Response to Submissions on the Separated Cycle Lane Proposals for State Highway 1, Dunedin

From consultation undertaken during November and December 2013

Cross- section for Option 1A: uni-directional cycle lane with parking.

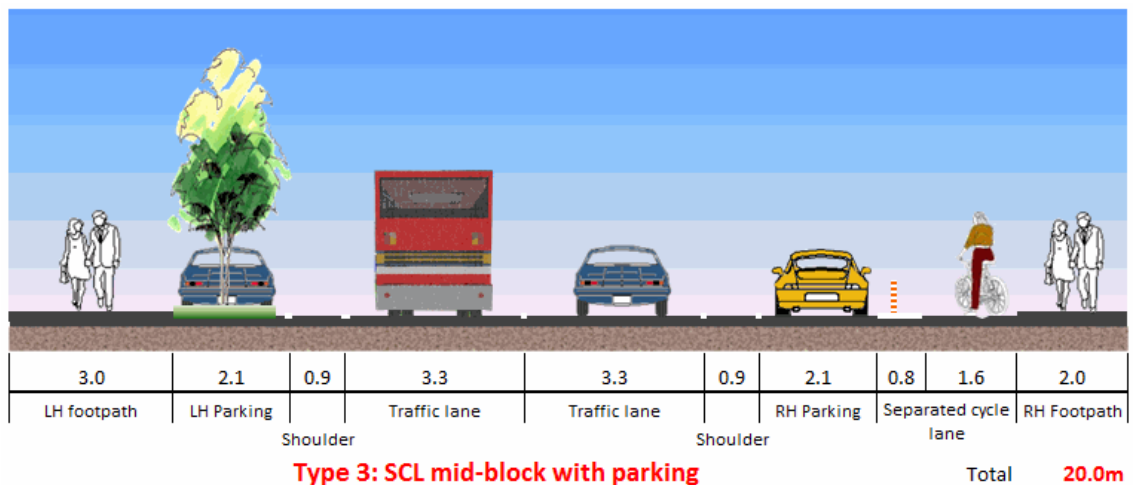
In light of the ‘user’ preference for uni-directional cycle lanes on each of the routes of the one-way system, together with the concern raised in relation to net parking loss, the Working Group developed a further option. This option, which is continues to be based on Option 1, seeks to also incorporate parking adjacent to the cycle lane on some blocks. This is referred to in this report as Option 1A.

The key difference for Option 1, is that in a number of situations it is proposed to narrow the footpath from its’ nominal 3m width, to 2m width. Combined with a narrowing of the cycle lane, this would enable parking to be retained between the new cycle lane and the near traffic lane. In this way, it is the car parking spaces (and cars within them) that achieve the desired separation from through traffic.

This modified cross-section is only potentially suitable for those blocks with no, or few, accesses; and where the level of pedestrian use of the footpath can still be managed.

Although attractive in terms of reducing parking loss, it also comes with its own set of consequences. Within the originally promoted 2.6m cycle lane width, the buffer between cyclists and parked cars needs to be accommodated. There is also an introduced risk between pedestrians and cyclists, as people alight to and from their parked vehicles. While the safety consequences are less – than incidence between cyclists and moving traffic, they are safety consequences all the same. It is a
